NSLPP MEETING HELD ON 06/07/2022

ADDRESS: 9 Carlyle Lane, Wollstonecraft

APPLICATION No: DA 447/21

PROPOSAL: Alterations and additions including new dormer addition

Figure 5 – Annotated Section BB (02-03-02 Rev A) showing height of dormer and skylights measured in a vertical distance from ground level (existing)

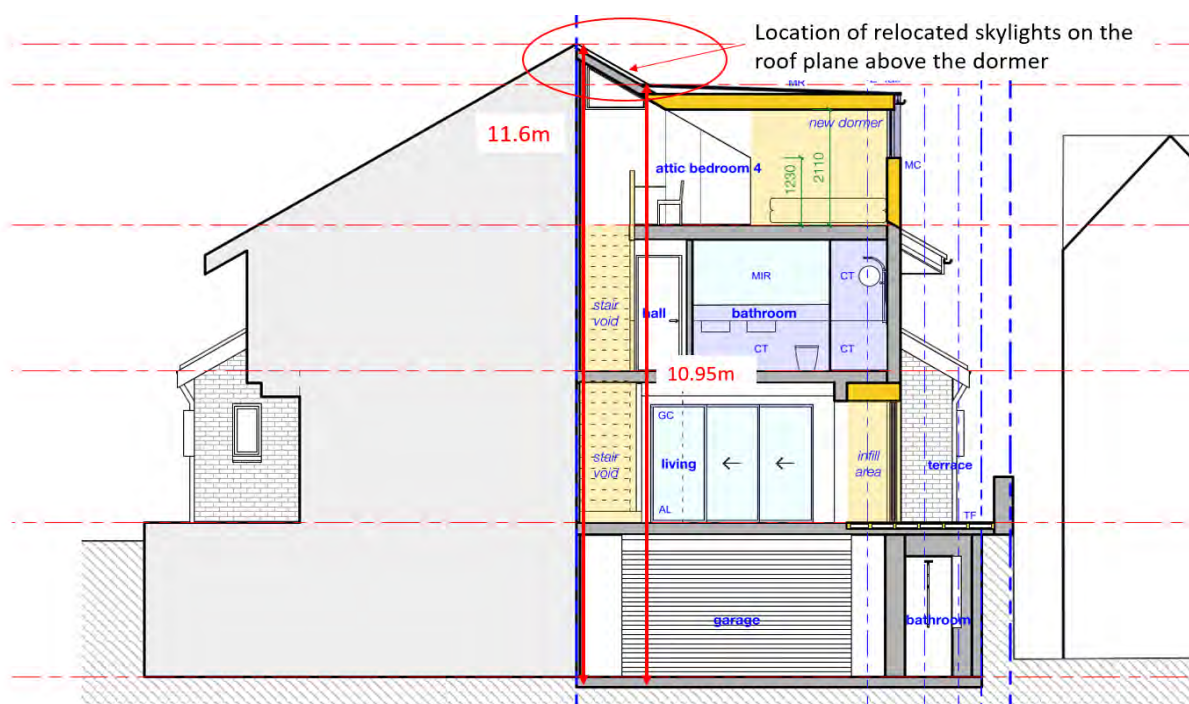
The proposed dormer would have a maximum height of 10.95m and the skylights relocated between the dormer and ridge of the semi-detached dwelling have a height of 11.5m which fails to comply with the permissible height limit of 8.5m not in accordance with clause 4.3 in NSLEP 2013 (exceedance of 29% for the dormer and 35.29% for the skylights). The sections below highlight the non-compliances with the height limit of 8.5m. The relocated skylights are above the maximum 8.5m height of building and the approximate location of the relocated skylights above the dormer are circled in red.

The proposed dormer as shown within Figure 6 is 10.95m measured vertically from existing ground level and the relocated skylights located just below the roof ridge have a height of 11.5m as shown in Figure 5 exceeding the maximum 8.5m height of building by 2.45m for the dormer and 3m for the skylights.

Figure 7 – Annotated Survey Plan prepared by John R. Holt Surveyors Pty Ltd for DA 444/10 (never constructed) showing RLs of bay window and balcony providing views to the rear of 5 Balfour Street

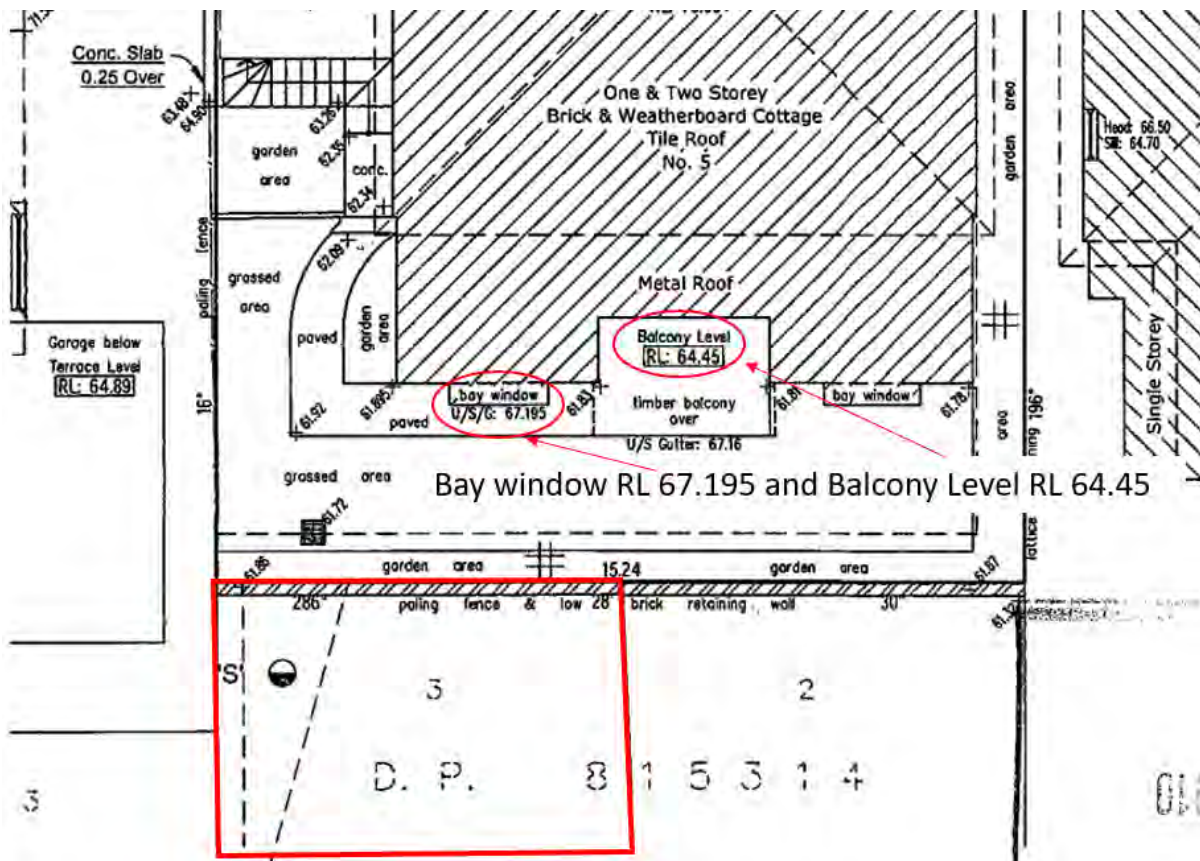
5 Balfour Street is sited on higher land than the subject site. This is highlighted below in the Survey Plan submitted with Development Application No. 444/10 for alterations and additions to 5 Balfour Street. The levels of the bay windows are 67.195m and the balcony level RL is 64.45m. Due to the elevated height of the property 5 Balfour Street located to the rear of the subject site the dormer addition at a maximum RL of 65.445m would retain district views from the rear of 5 Balfour Street. Below is a photo taken from Balfour Street confirming the elevated topography of 5 Balfour Street and existing district views comprising land views, not water or iconic views.

Figure 10 - Shadow Diagram at 9.00am in mid-winter (June 21) detailing shadow cast from the dormer affecting the roof of the existing semi-detached dwelling (SDP-04 Rev A)

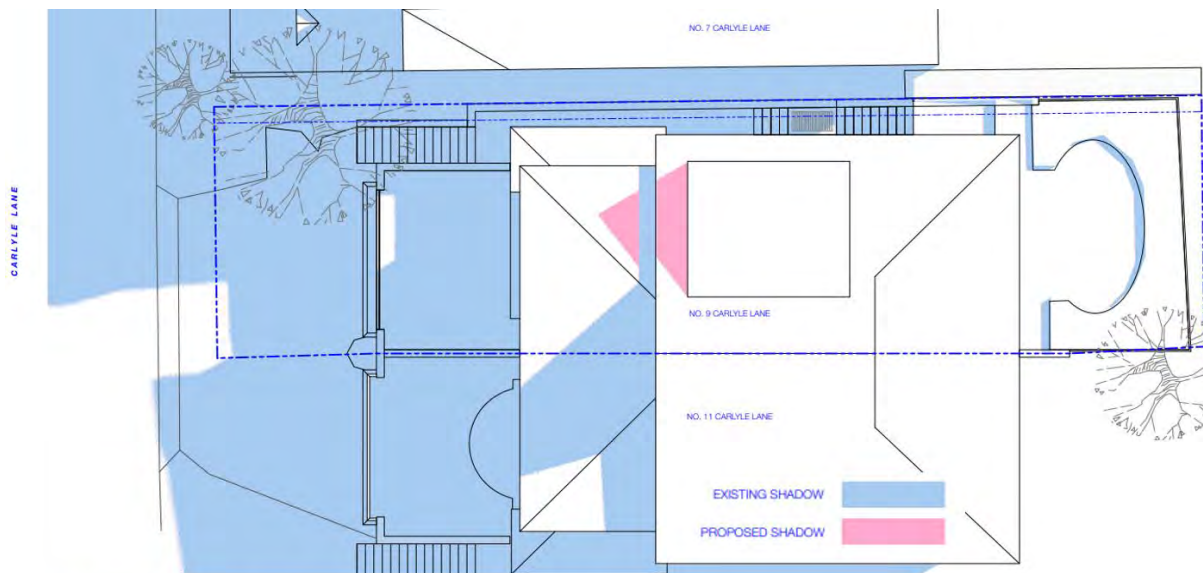
The application includes shadow diagrams at 9am, midday and 3pm for 21 June (mid-winter) confirming the existing dwelling subject to alterations and additions (internal alterations and a side dormer and relocated skylights) would not cause any additional shadows for surrounding dwellings or the streetscape.

Consequently, the development maintains the existing solar access afforded to existing dwellings and the street in accordance with the planning objective concerned with solar access to surrounding properties (see figures 10-12 below).

Figure 13 – Annotated North Elevation (Dwg No. 02-02-02 Rev A) identifying views from the dormer directed to the western roof slope of 7 Carlyle Lane

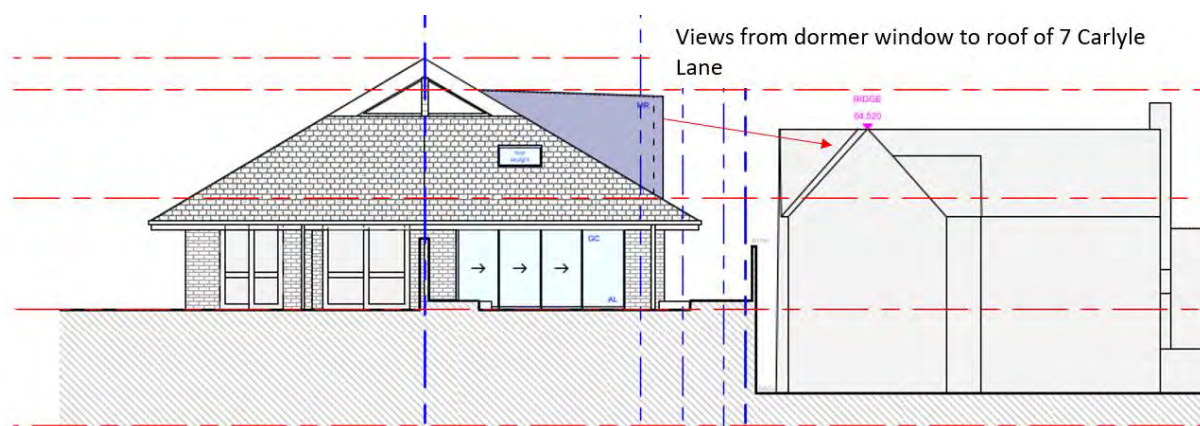
The proposed additions to the existing attic bedroom to form a larger bedroom with an ensuite entails a dormer and relocation of two skylights. The skylights would direct views skywards and not towards the windows of neighbouring habitable rooms or the private open space of adjoining properties. The dormer includes three windows modest in size directing views towards the roof of the neighbouring property 7 Carlyle Lane not having any direct views to habitable rooms of the adjoining property and having no discernible impact on the visual amenity of the western neighbour. The skylight and dormer are appropriately sited on the side roof and designed to minimise overlooking of adjoining properties with predominant views directed to either the sky or the roof of the rear wing of 7 Carlyle Lane. Below is an annotated northern elevation and a nearmap image showing the no windows on the roof of the rear wing of 7 Carlyle Lane.

Figure 15 - Annotated Site Plan (Dwg No. 02-01-01 Rev A) detailing the setbacks of the dormer and principal elevations to Carlyle Lane

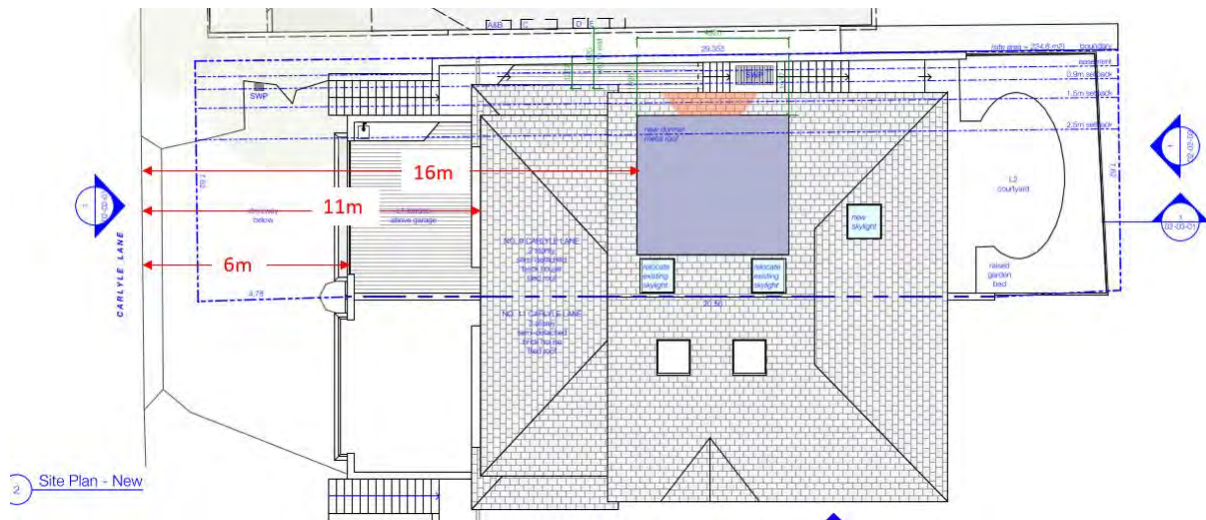
Furthermore, the dormer is sufficiently setback from the principal elevation facing Carlyle Lane and due to the elevated character of the dwelling above the street the dormer addition will not be easily visible from the streetscape therefore having a limited impact on the character of the public realm (refer to below site plan and street photograph).

Figure 21 – Level 2 Floor Plan showing stairs adjoining party wall and rear addition with nil setback (left) and photo of the rear elevation subject to an infill addition (right)

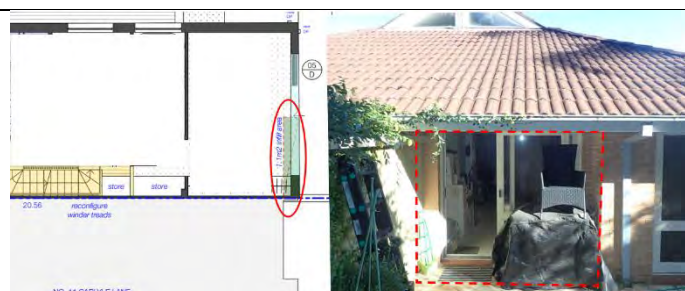
The infill addition abutting the side boundary with 11 Carlyle Lane is highlighted above and is considered a minor addition small in scale not having any adverse impact to the neighbouring properties in terms of overshadowing and visual privacy.
